April 13, 2012

RE: Crystal Lake – Groundwater Well Review
Dane County, WI
GEC#: 1211-266A

Per your request we have reviewed the available documentation regarding the potential construction of a groundwater well to lower the water surface level of Crystal Lake located in Dane and Columbia Counties. The construction of a groundwater well to be used as a means to drawdown Crystal Lake does not appear to be a viable option.

Sieve Analysis ID # 111411-2

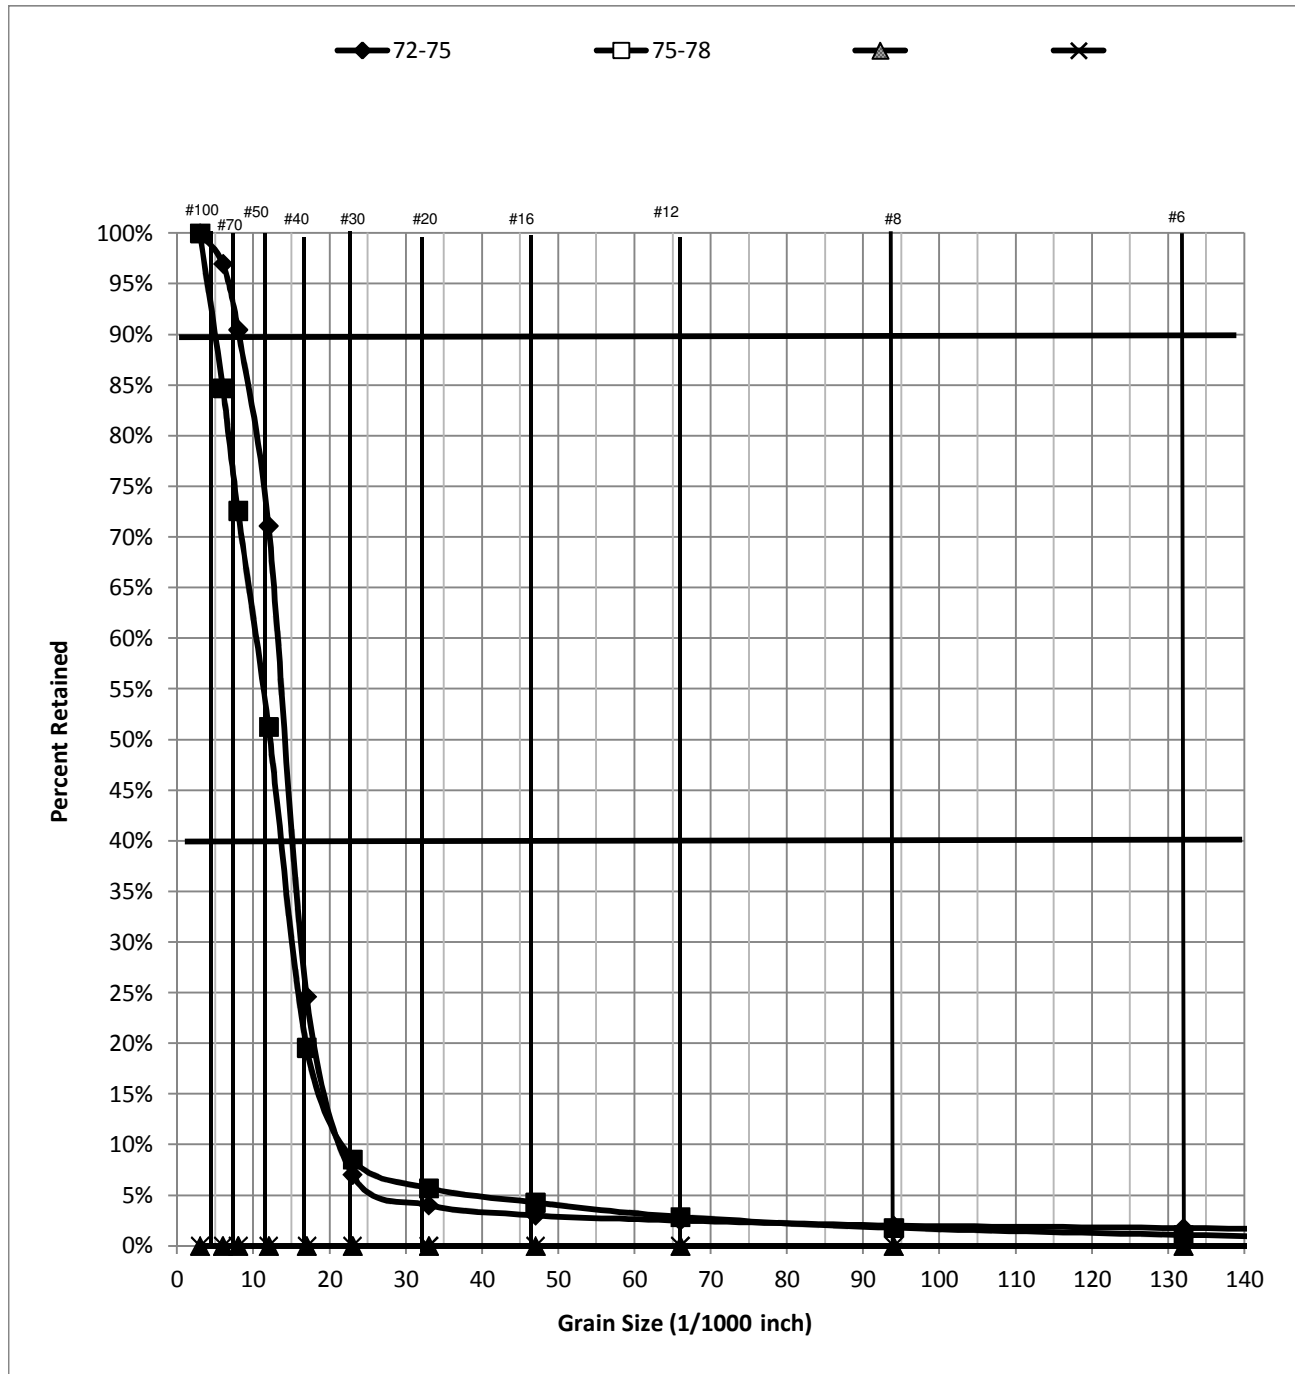
Test wells installed by the Lakes District near the shore of the lake indicated that the geology is not suitable for a high capacity production well. In addition, the static water level measurements indicated that any production zone for a pumping well would have a very poor hydraulic connection to the lake. Sieve analyses of the native soil for two test wells drilled by Sam's Well Drilling were completed in the location of the proposed well. The results of the analyses estimated a yield of 100 – 200 gallons per minute (gpm) and a static water level of 20'. The analyses are attached for reference. If it is assumed that the well would produce the maximum yield of 200 gpm; it would require running the well continuously for nearly six years to draw the approximately 620 acre lake down three feet in elevation. That is assuming all water drawn from the well directly impacts the water level in the lake. If it is assumed that ten percent of the water drawn from well affects the lake level it would require approximately 60 years of continuous pumping to draw the lake down three feet.

Well:
Contractor: Sam's Well Drilling
Estimated Yield - 100 - 200 GPM, SWL - 20'
Sample 49' - 60' (Mostly Clay)
